# **Beaufort West Solar PV Energy Facility (SEF) and Associated Infrastructure near Beaufort West in the Western Cape Province:**

## **Draft Amendment Report for Environmental Authorisation (EA) (DFFE Reference: 14/16/12/3/3/1/2673)**

Report Number 612156/1/ Rev1

**Figure 3-1: Illustration of the effect of change in pitch on panel yield and vegetation clearing requirements**

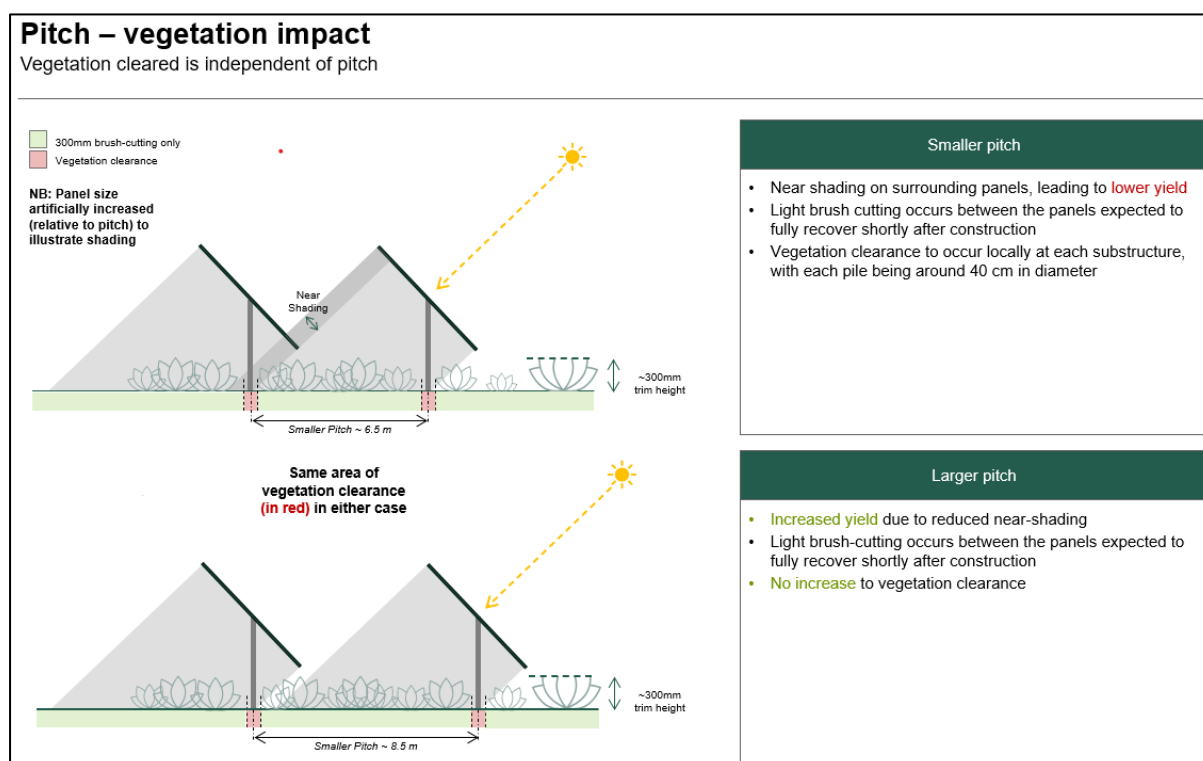
- The PV panel row spacing has increased from 6 m (in the approved layout) to 8 m to improve efficiency of the panels by decreasing shading from nearby panels. This has resulted in a reduced ground cover ratio (i.e. more open space between panels). While this increases the fenced perimeter, the vegetation clearing required remains within authorised thresholds due to the retention of intact vegetation (strip clearing) between PV panel rows. Additional detail of this is provided in Section 3.3. *Note: this difference in panel spacing and vegetation clearing was not specifically described in the previous version of the amendment report.*

The increased spacing between the rows of panels (from 6 m to 8m), is primarily to accommodate a higher pitch of the solar panels, which reduces near shading from adjacent panels and improves operational efficiency. This design change has a direct impact on vegetation clearance requirements, as it facilitates the retention of vegetation strips between the panel rows. The effect of pitch on near shading and vegetation clearing is illustrated in Figure 3-1 below.

Figure 3-5: Proposed (preferred) amendment layout

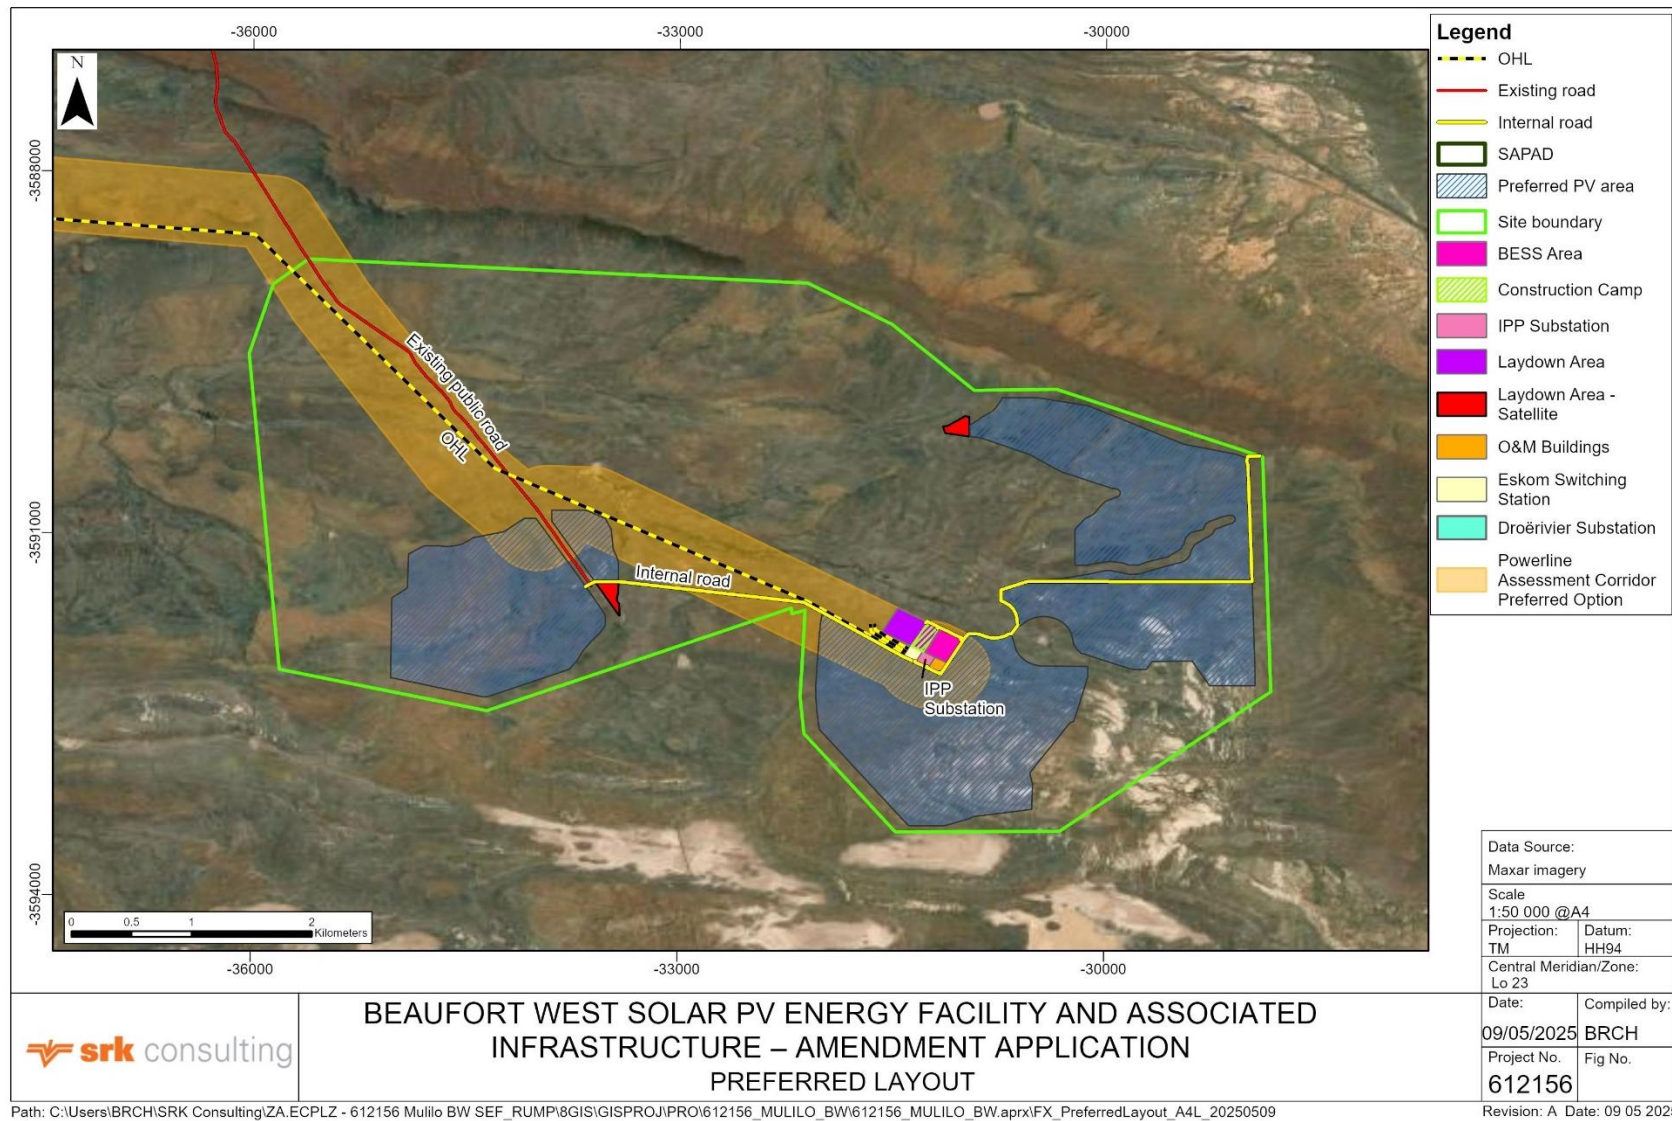
- Changes to the location of temporary laydown areas (for construction only and subsequent rehabilitation) at the PV array areas, totalling 4 ha, as shown on **Figure 3-5**. *Note: the previous version of this report showed three temporary laydown areas – this has been reduced to two, as one of these areas was considered to be unnecessary due to its proximity to the permanent laydown area;*

**Figure 3-7: Previously authorised (in grey) vs. proposed preferred (in black) amendment layout map**

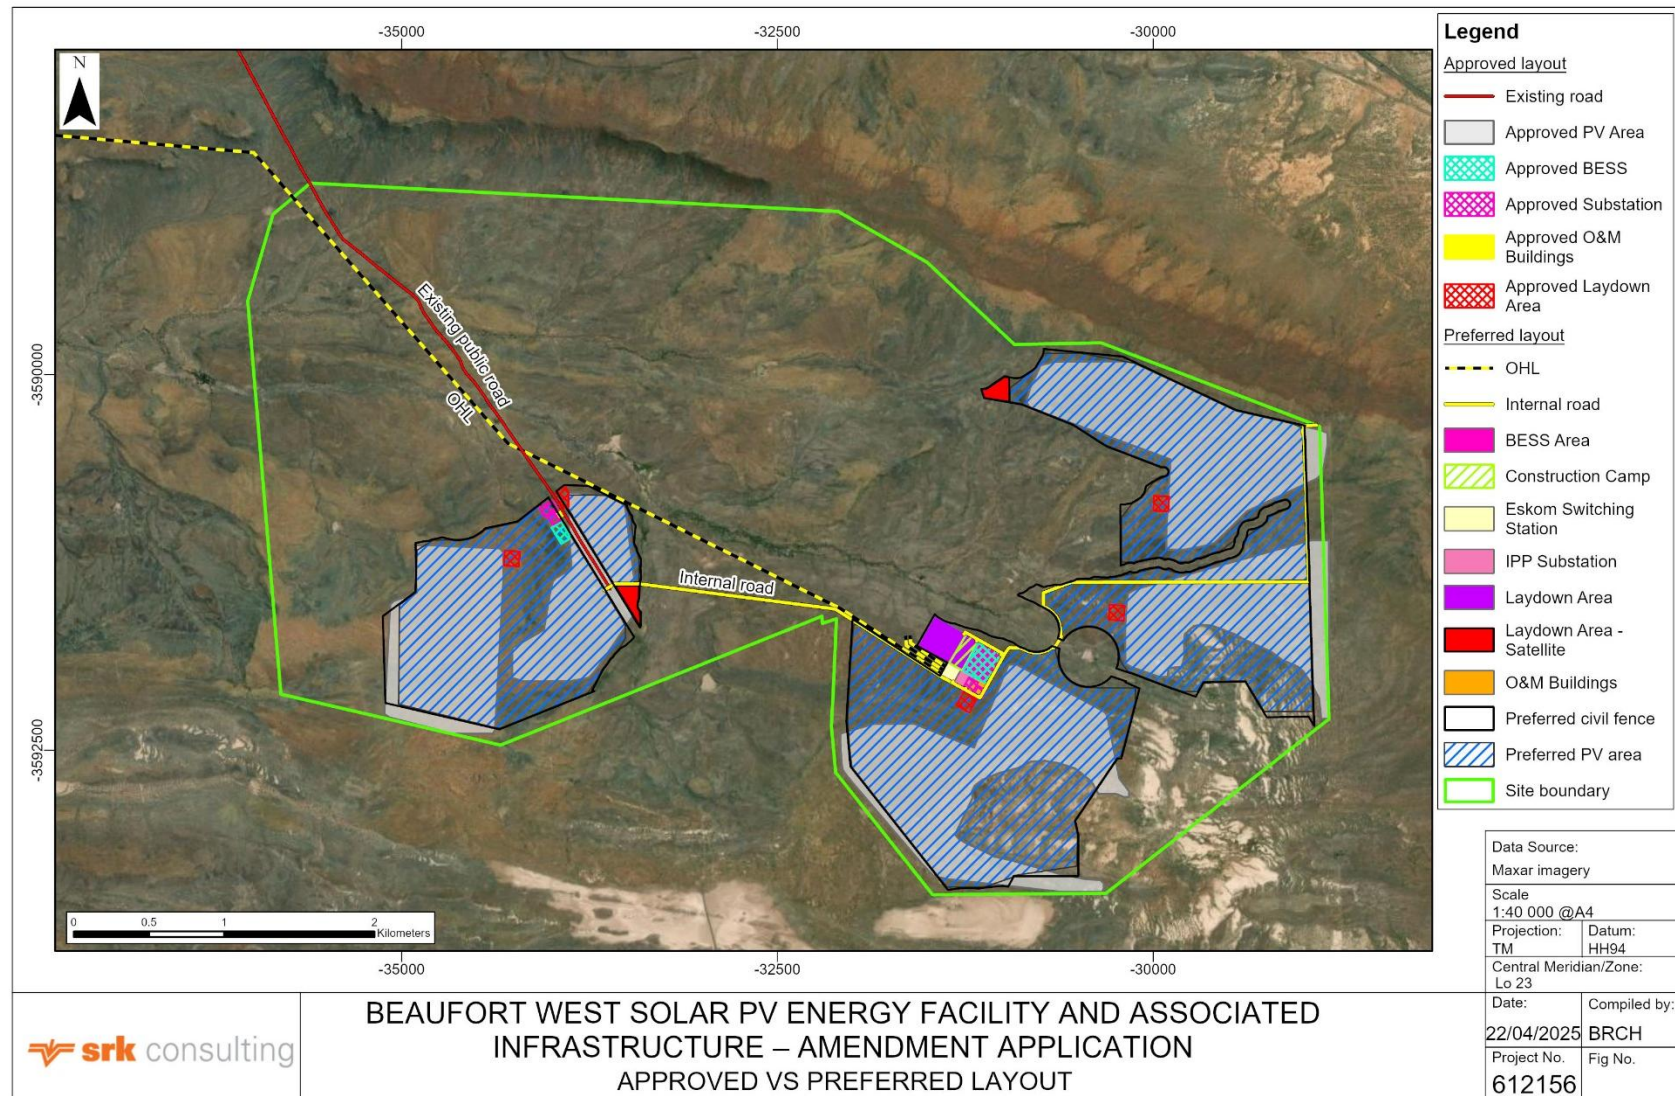
- Revision of the layout of the solar PV arrays, largely remaining within the previously authorised footprint area, and avoiding sensitive areas identified by specialists based on their previous studies, with updated sensitivity mapping with regard to aquatic features. The Developer worked closely with the relevant specialists to ensure the proposed amendments to the development footprint are acceptable. *Note: the layout presented in this report differs from that in the previous version of the amendment report, in that it reduces overlap with CBAs.*

The required changes to the EA in response to this amendment are detailed in the Amendment Application Form, a copy of which is provided as Appendix F, as well as Table 3-1 below (changes indicated in **bold** text). A map showing the previously authorised layout relative to environmental sensitivities identified on site is provided in Figure 3-6, and a comparison of the authorised and proposed amended layout is provided in Figure 3-7, with zoomed in layout maps showing this comparison of layouts provided in Appendix G.

**Figure 6-1: Proposed preferred layout relative to previously identified avifaunal sensitivity areas (Source: AfriAvian, 2025)**

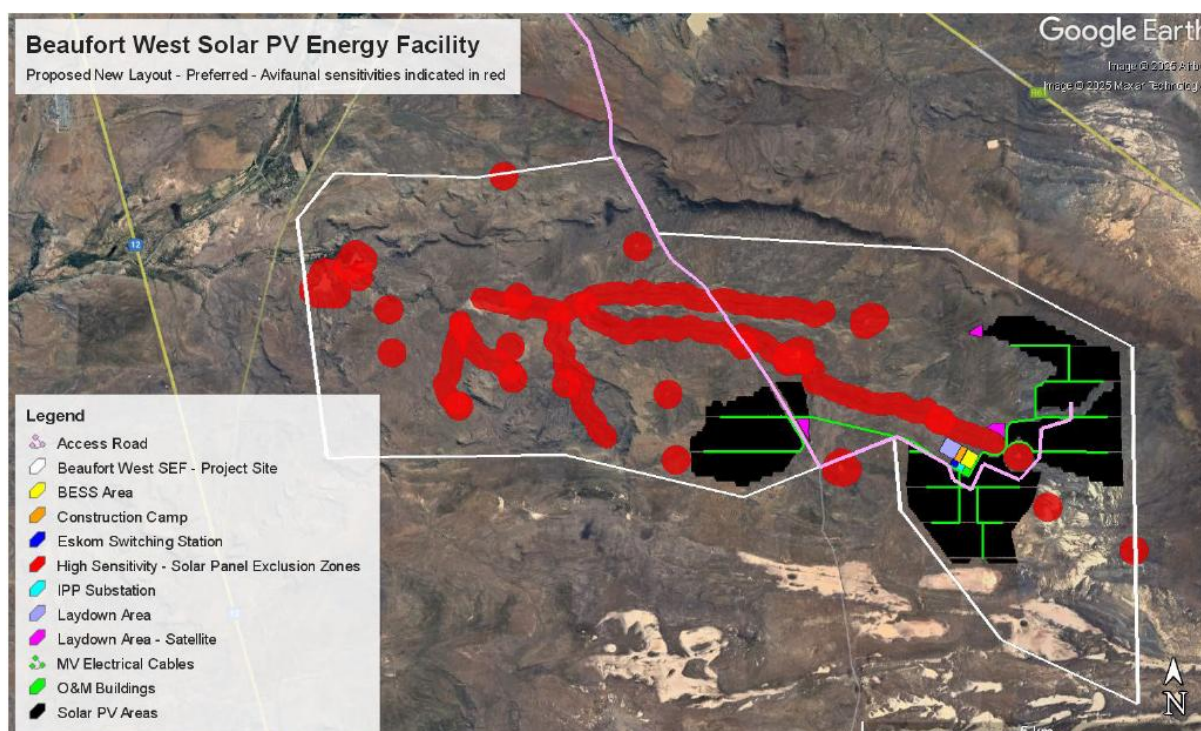
In reviewing the proposed amendments, Albert Froneman of AfriAvian Environmental (Pty) Ltd confirmed that neither the preferred nor alternative layouts would change the nature or severity of avifaunal impacts. It was also confirmed that the mitigation measures recommended in the

Avifaunal Impact Assessment (Chris van Rooyen Consulting 2022<sup>2</sup>) would not require any changes and remain valid and both amended layouts were found to be acceptable from an avifaunal perspective. The avifaunal sensitivity areas that were identified in the original assessment are mapped in Figure 6-1 below relative to the proposed preferred layout.

**Figure 6-2: Proposed amended layout alternatives for the project, shown together with the mapped aquatic features**

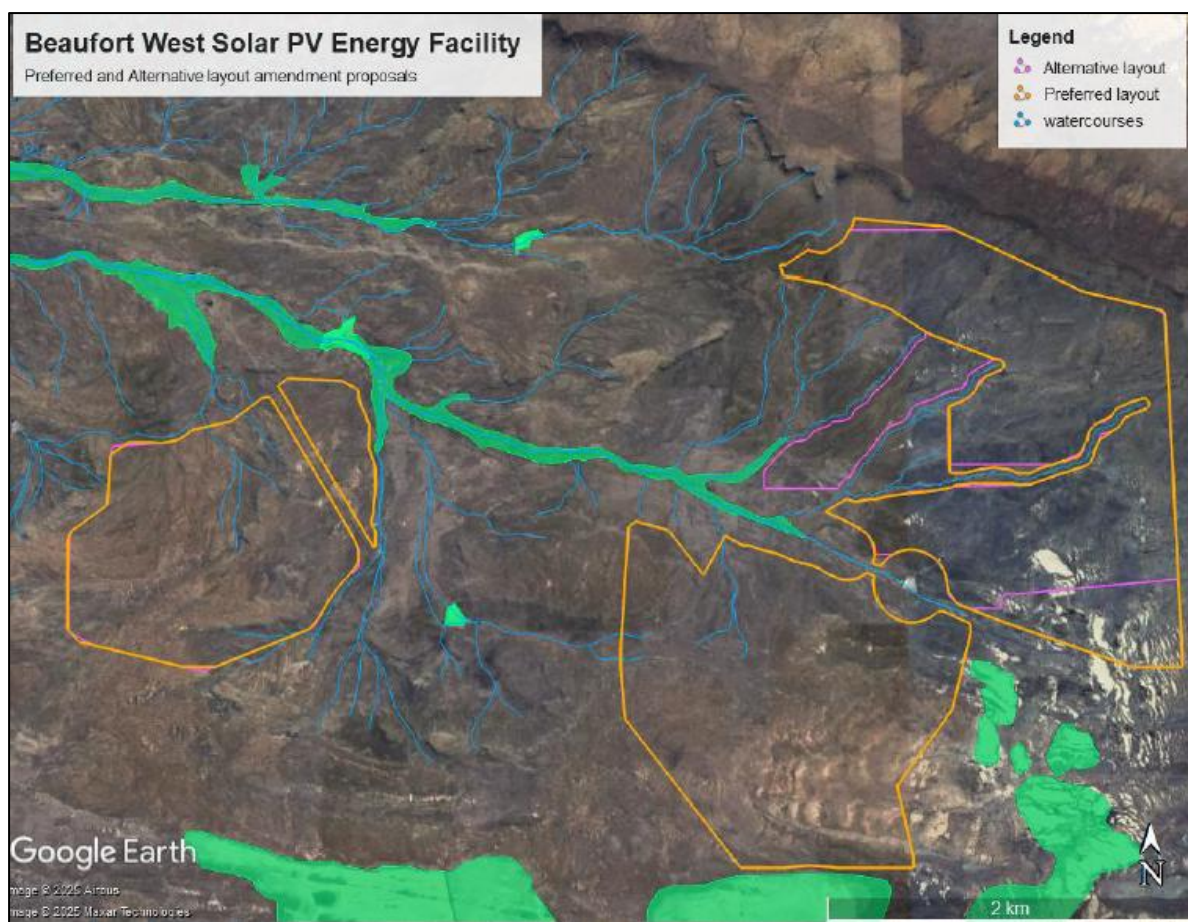
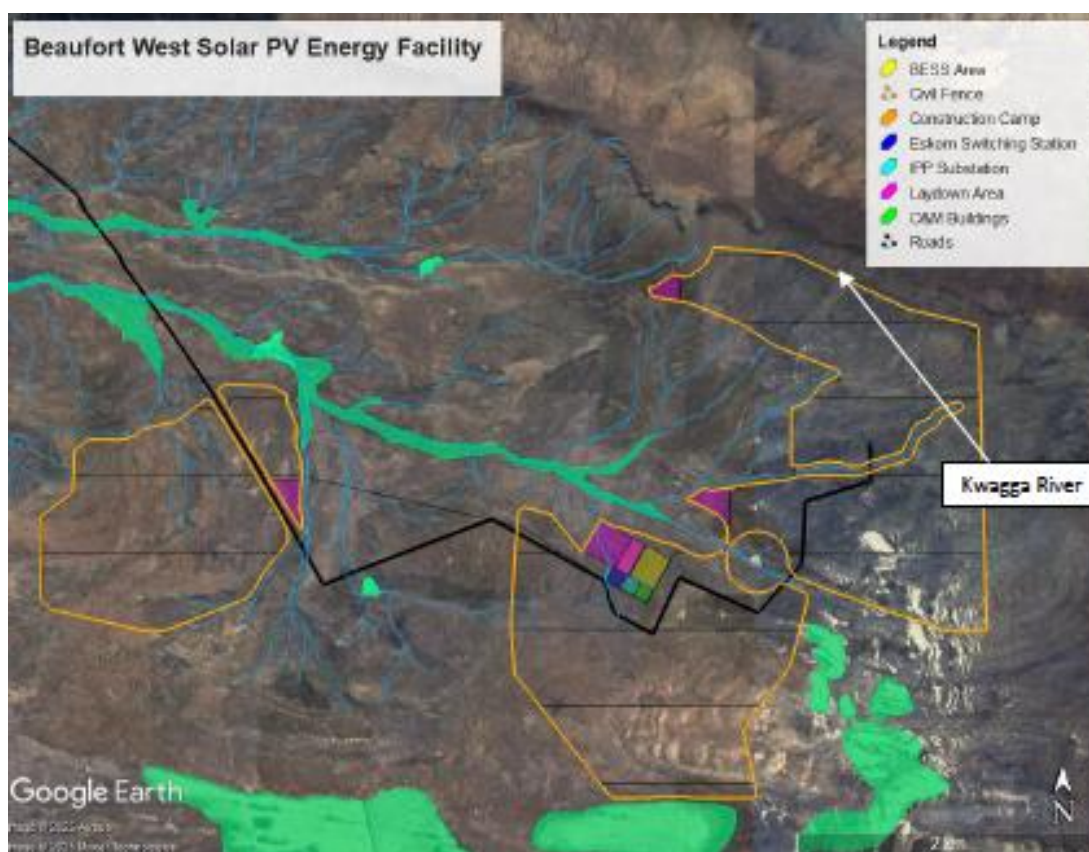
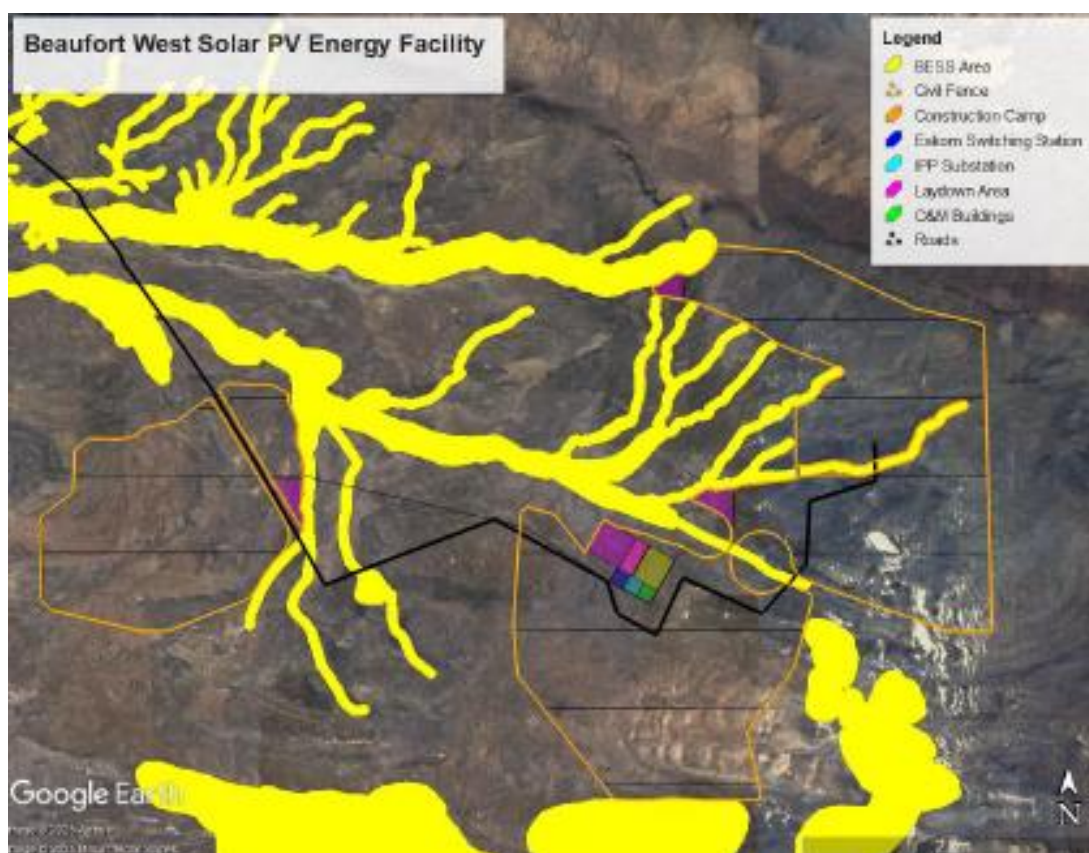
As part of this amendment process, Blue Science conducted a follow-up site visit after rains to verify on-site conditions and assess the impacts of the proposed layout changes. This resulted in a decrease in the extent of high sensitivity features compared to what was mapped in the original assessment. The specialist concluded that widening of access roads where they cross watercourses can easily be mitigated such that there would be no increase in impact. The areas where the PV modules and associated infrastructure (in the proposed amended layout) have extended into the areas mapped as being of very high sensitivity in the southeast of the project area are within an area mapped as a depression wetland. During ground-truthing this area was found to often be higher-lying and with patches devoid of vegetation, and was not associated with any wetland habitat. The other areas mapped as being of very high sensitivity related to smaller watercourses that are tributaries of the Kwagga River, that were mapped as aquatic Ecological Support Areas (ESA), but ground-truthing determined them to comprise minor watercourses and drainage features of little aquatic ecosystem significance and providing little in terms of ecological services. The upper reaches of the larger Kwagga River and a 30m buffer that is mapped as an aquatic CBA are avoided by the proposed amended layout (Figure 6-3 and Figure 6-4). Apart from these changes, aquatic ecosystem characteristics were found to be unchanged, and the ecological condition and sensitivity of aquatic features remained consistent with the original assessment. While the amended layout results in slightly increased proximity to ground-truthed aquatic features, including depression wetlands in the southeastern portion of the site, this was not considered to alter the nature or severity of impacts originally assessed.

headwater areas of the Kwagga River affected by the alternative layout. The significance of aquatic impacts remains LOW (-ve), consistent with the original assessment findings.
